Site: Unser/McMahon Mixed Use Subdivision Lots 1, & 3-7

Re: Drainage Ordinance (§14-5-2-11) Violations for Erosion and Sediment Control

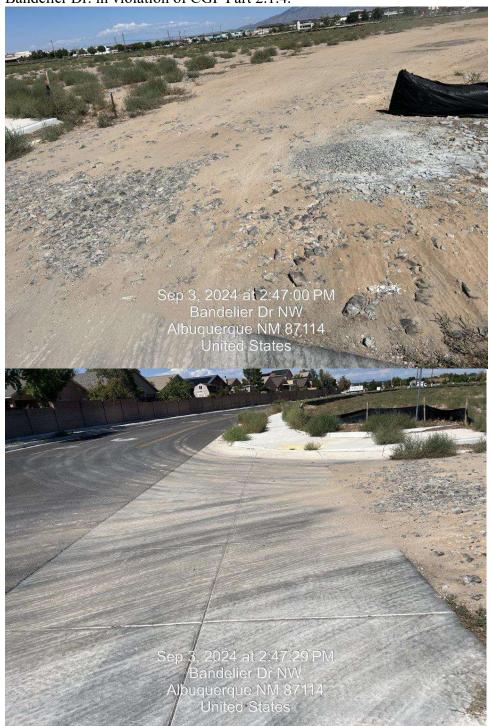
- 1. The **Posting** of permit coverage was missing in violation of CGP Part 1.5.
- 2. The **SWPPP** and self-inspection reports were unavailable during the time of inspection in violation of CGP Parts 4.7.3 and 7.3.
- 3. Washout was observed on your site at the construction exit in violation of CGP Part 2.3.4.

- 3. Direct wash water into a leak-proof container or leak-proof and line pit designed so no overflows can occur due to inadequate sizing or precipitation per CGP Part 2.3.4. Do not allow liquid wastes to be disposed of through infiltration or to otherwise be disposed of on the ground.
